# PRODUCT BULLETIN

# NO. 172

## THE MODEL 2260BC AND MODEL 2260C SERIES DISK DRIVES

FIGURE 6 7488 BOARD

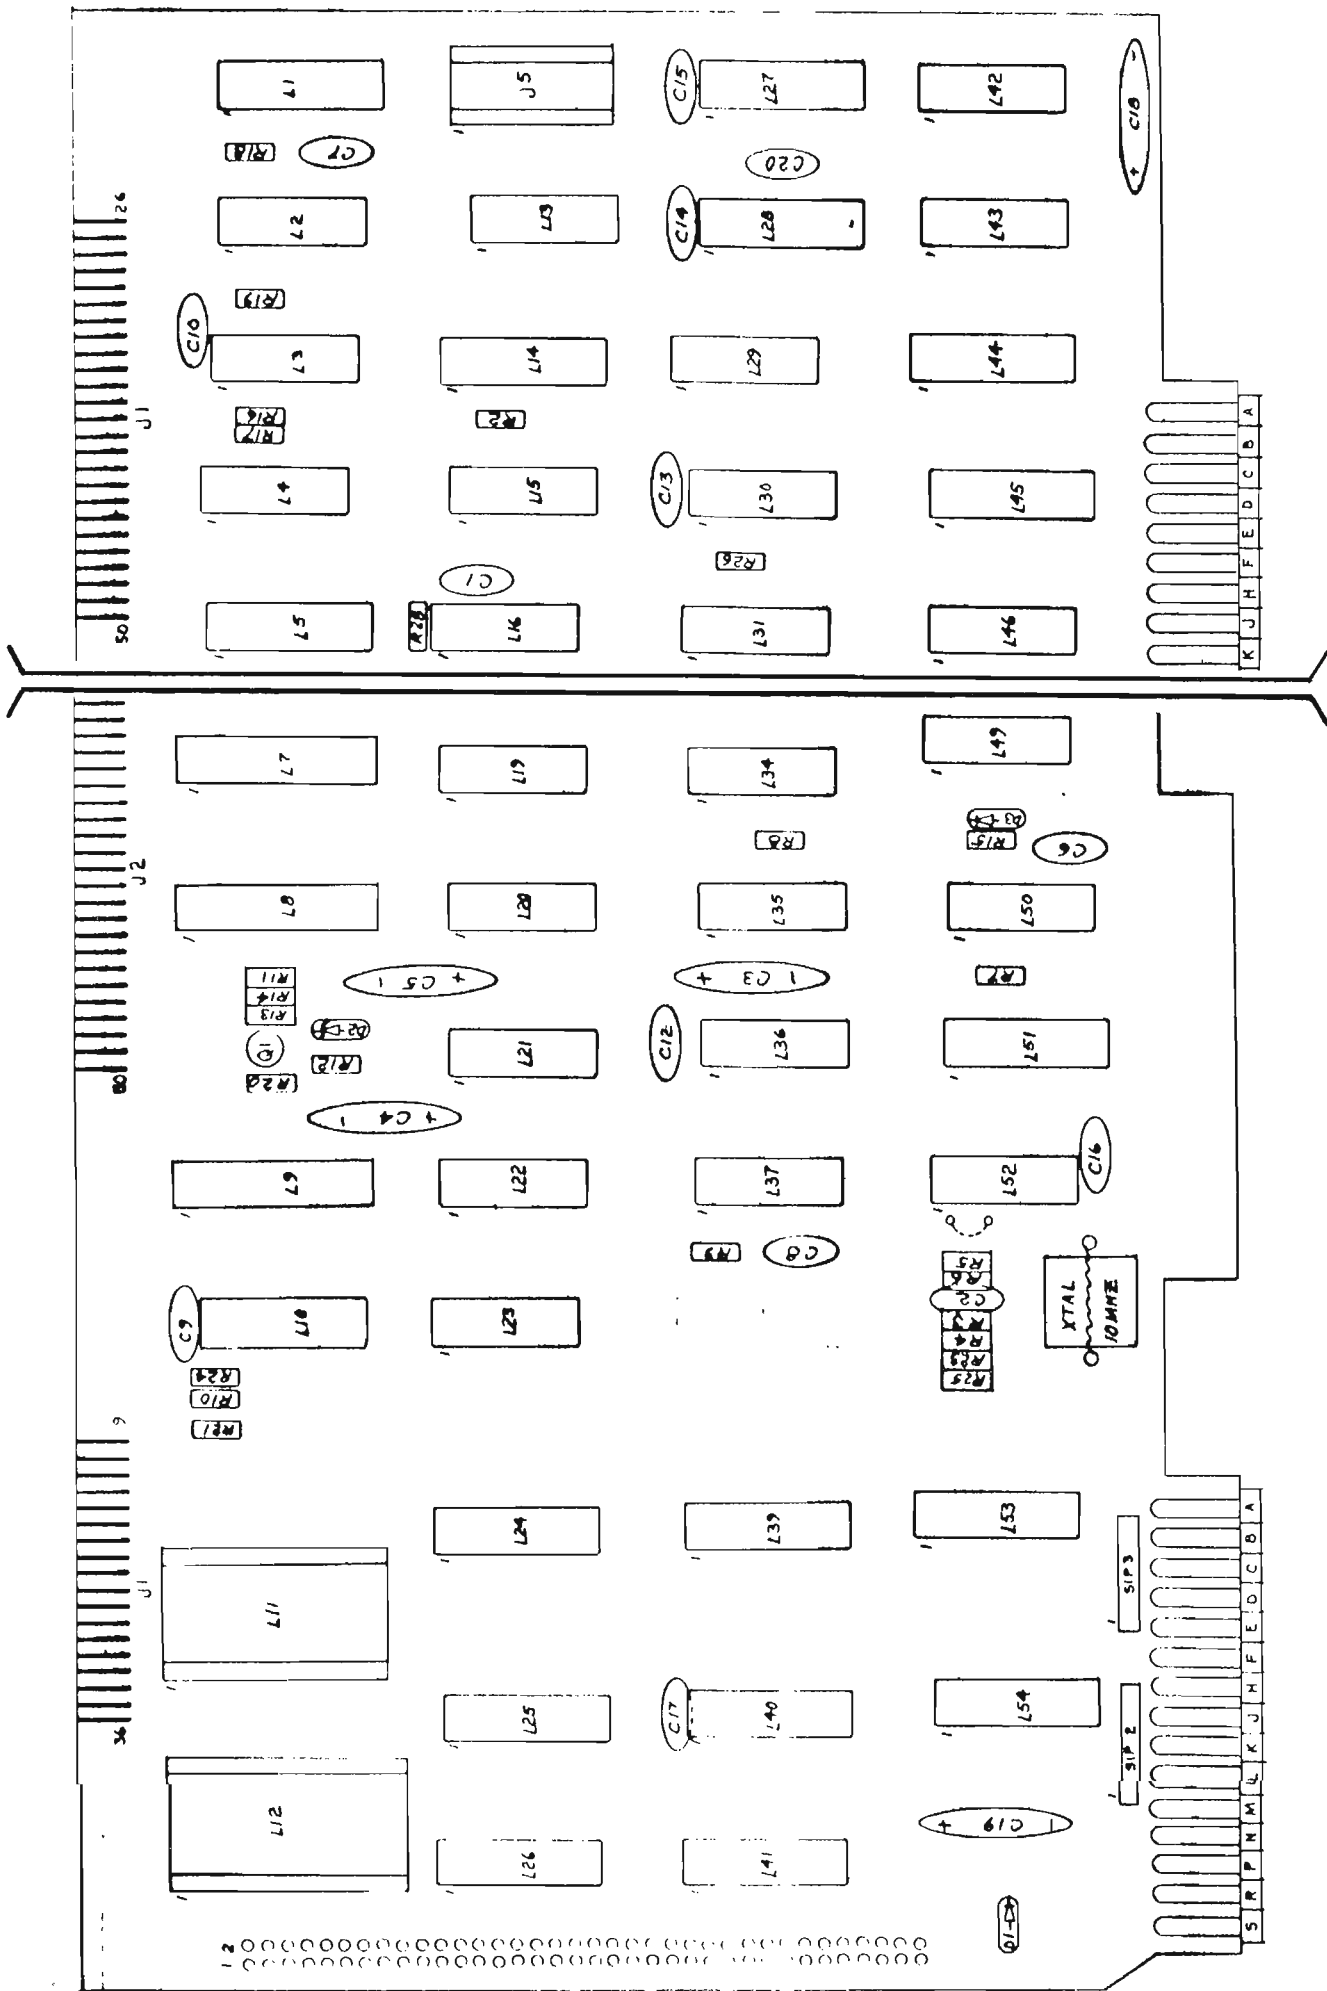
- 2) ECN #9500 - Change C1 from .01 uf to .002 uf (WL #300-1913). On the schematic diagram for this board, the capacitor can be found at coordinates 2F10 (Sheet 2, @ F10). Without this change, intermittent error 61's (I92) may occur. This ECN changes the 7488 E REV level from 0 to 1.

- 3) ECN #9700 - The cathode of diode D2 in the Write-Gate circuit should be attached to the junction of resistors R11 and R12, not the junction of resistors R11 and R13. Desolder and lift the cathode lead of D2 out, then connect it to the top of R12 (located next to D2). The top of R12 is connected to R11. The schematic should be changed to reflect the update. (Ref: Figure 4)

Additionally, R8 should be connected to +0V not +5VR. This resistor is part of the Clock Power-Up Clear circuit. (Ref: Figure 5)

FIGURE 3  
7486 BOARD

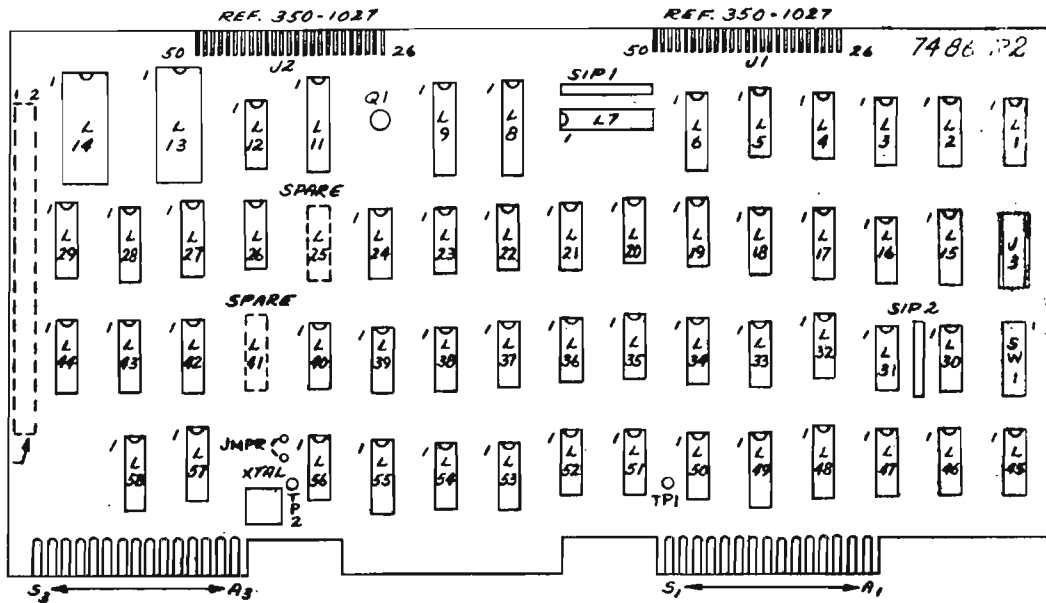
- 2) ECN #9462 - Change C1 from .01 uf. to .002 uf. (WL #300-1913). On R1 boards, this capacitor is located between L22 and L23; on R2 boards between L18 & L19. On the schematic diagram for the 7486 board, the capacitor can be found at coordinates 2F10 (Sheet 2, @ F10). Without this change, an intermittent error 61 (I92) may occur. This ECN changes the E REV from 1 to 2.

- 3) ECN #9628 - The cathode of diode D2 in the Write-Gate circuit should be attached to the junction of resistors R14 and R15, not the junction of resistors R15 and R17. Desolder and lift the cathode lead of D2 out, then connect it to the top of R14 (located next to D2). The top of R14 is connected to R15. (Ref: Figure 1)

Additionally, R10 (a 470-ohm resistor, located between L37 and L38) should be connected to + 0V, not +5VR. This resistor is part of the Clock Power-Up Clear circuit. (Ref: Figure 2).

4. ECN #9257 - Resistor R14 in the Write-Gate circuit should be 270 ohms, not 390 ohms. There is no E REV change associated with this ECN. (Ref: Figure 1)

FIGURE 6 7488 BOARD

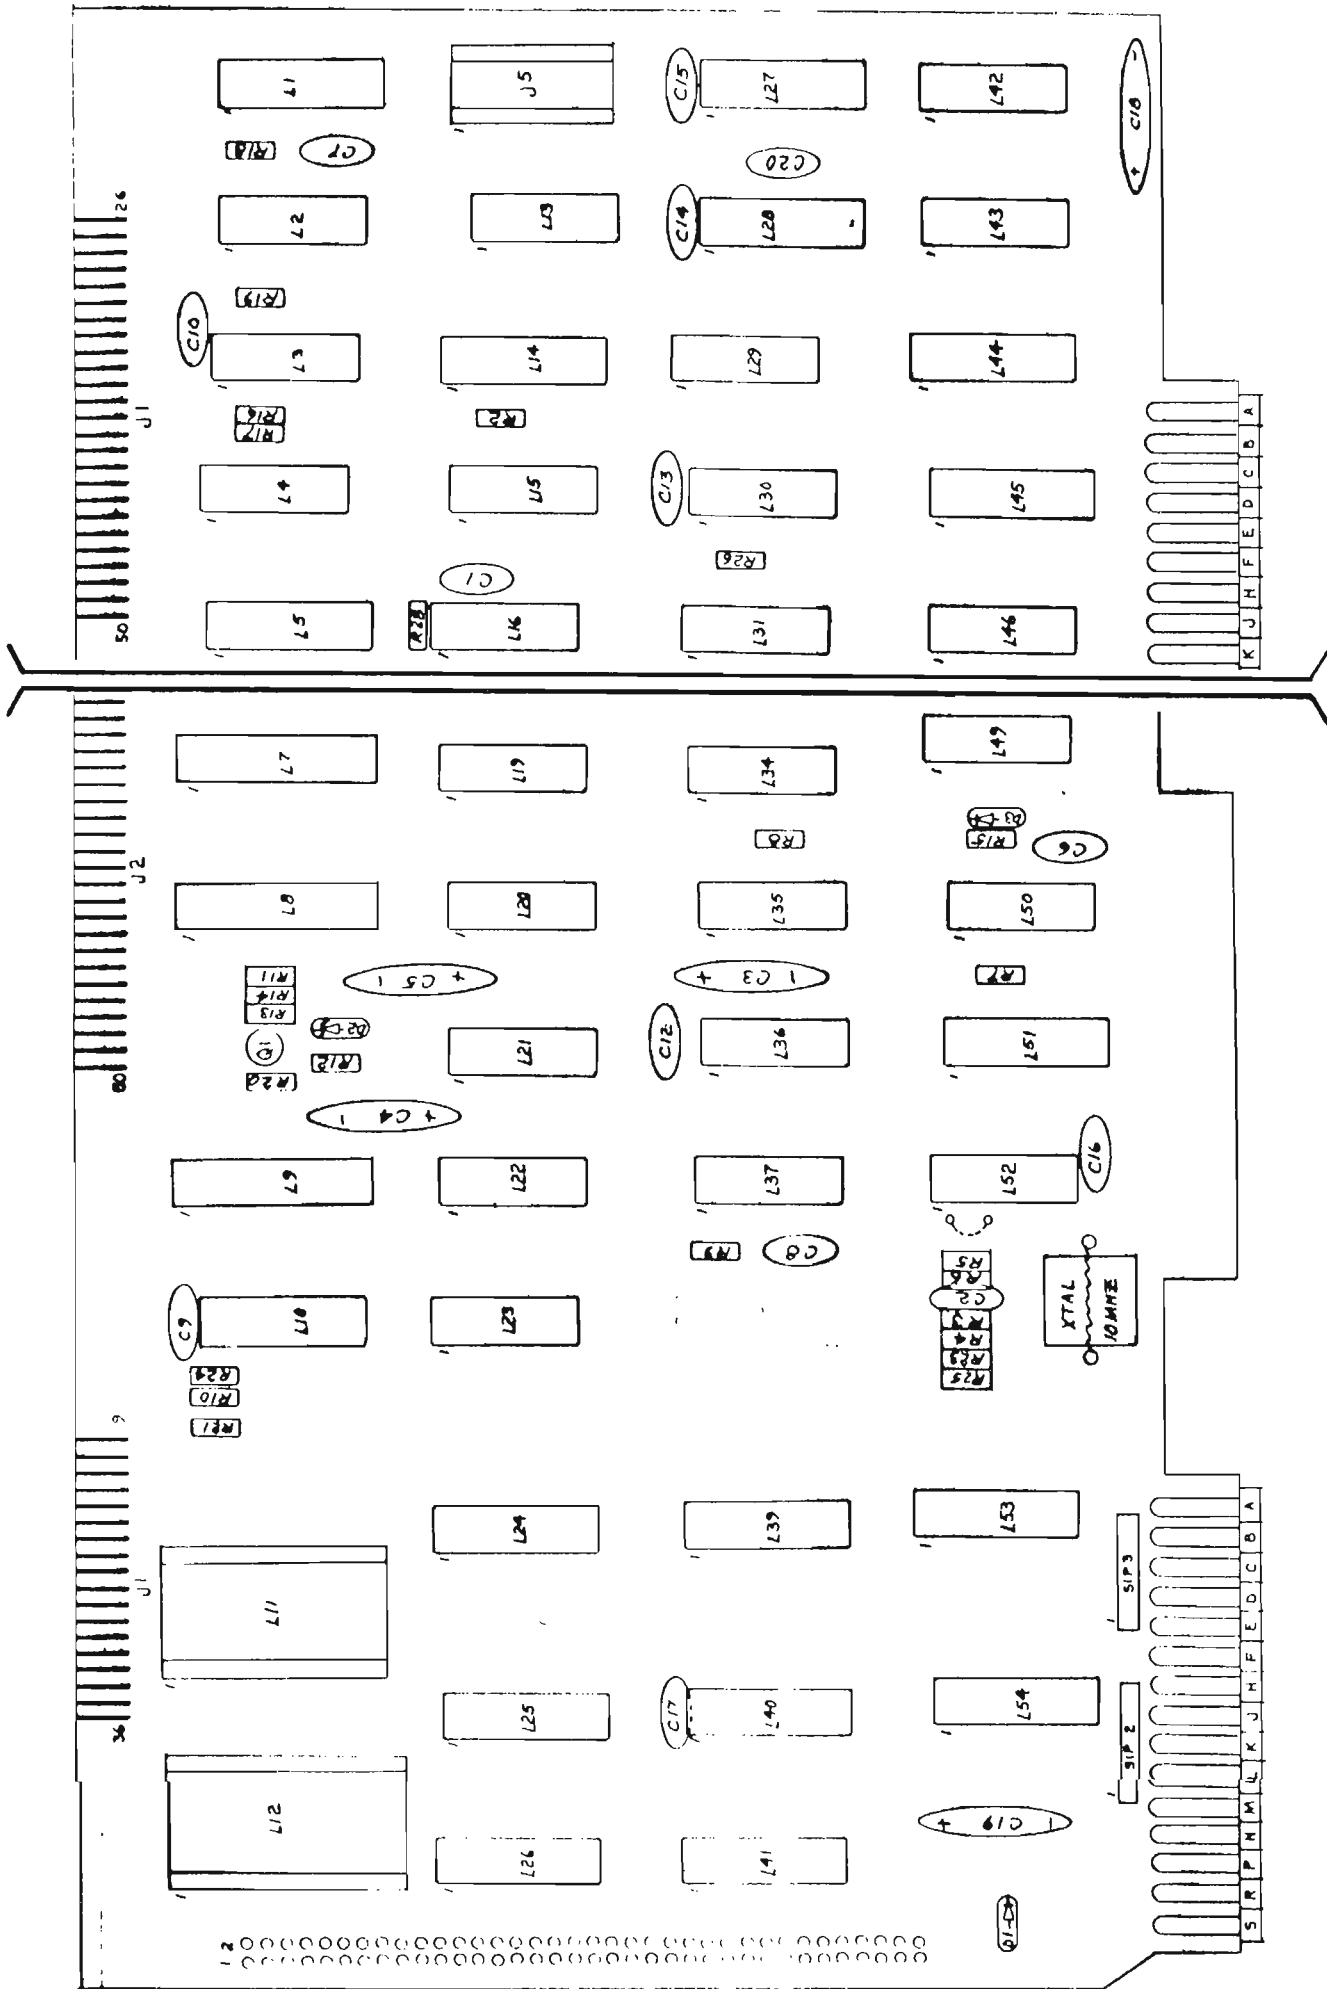
- 2) ECN #9500 - Change C1 from .01 uf to .002 uf (WL #300-1913). On the schematic diagram for this board, the capacitor can be found at coordinates 2F10 (Sheet 2, @ F10). Without this change, intermittent error 61's (I92) may occur. This ECN changes the 7488 E REV level from 0 to 1.

- 3) ECN #9700 - The cathode of diode D2 in the Write-Gate circuit should be attached to the junction of resistors R11 and R12, not the junction of resistors R11 and R13. Desolder and lift the cathode lead of D2 out, then connect it to the top of R12 (located next to D2). The top of R12 is connected to R11. The schematic should be changed to reflect the update. (Ref: Figure 4)

Additionally, R8 should be connected to ±0V not +5VR. This resistor is part of the Clock Power-Up Clear circuit. (Ref: Figure 5)

FIGURE 7 CIRCUITRY ADDED TO LOGIC BOARD

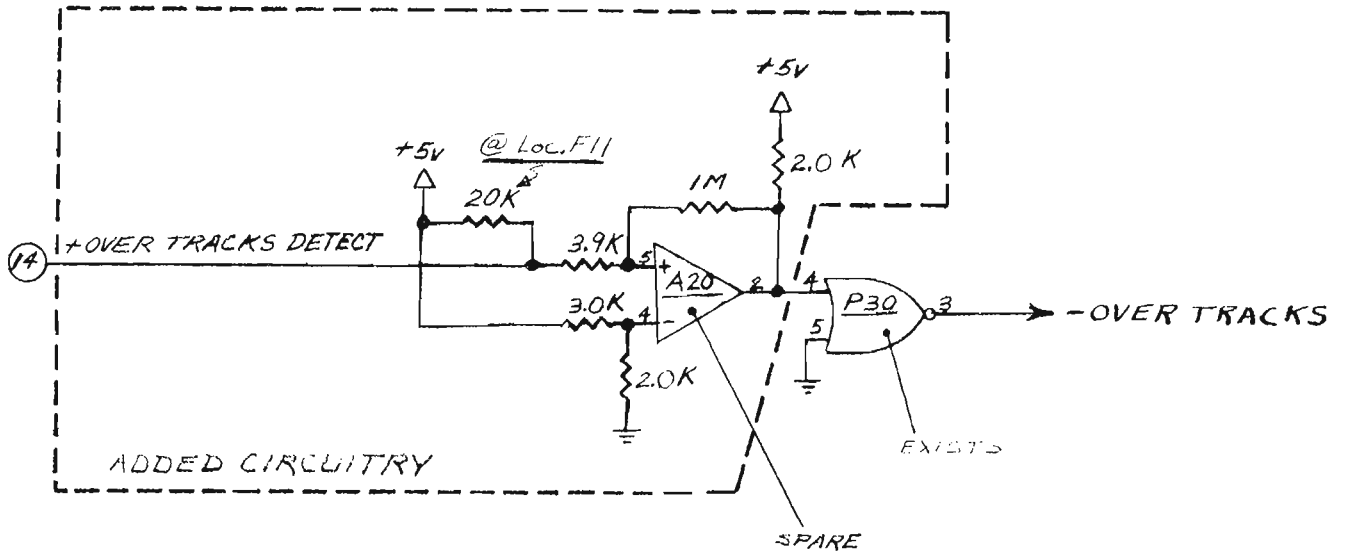
To update the "over tracks" detect circuit located on the LOGIC circuit board (Diablo #12066) the following additions and changes must be installed (see Figure 7 for circuitry added).

This change brings the LOGIC PC revision level to L.

ECN 16972 PCB 210-7688

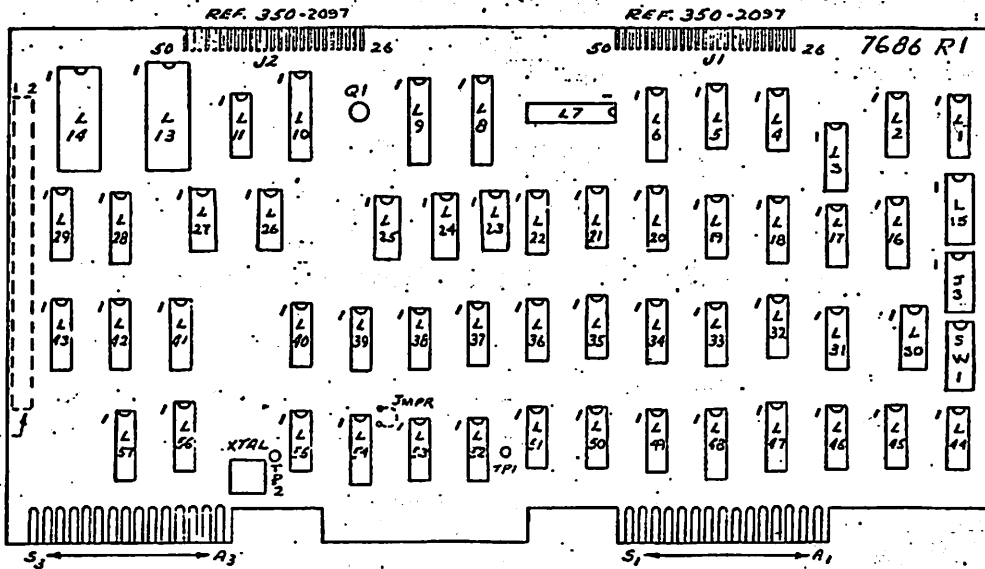
Purpose: To synchronize reset with the processor timing cycle to fix occasional writing on the disk when reset is used.
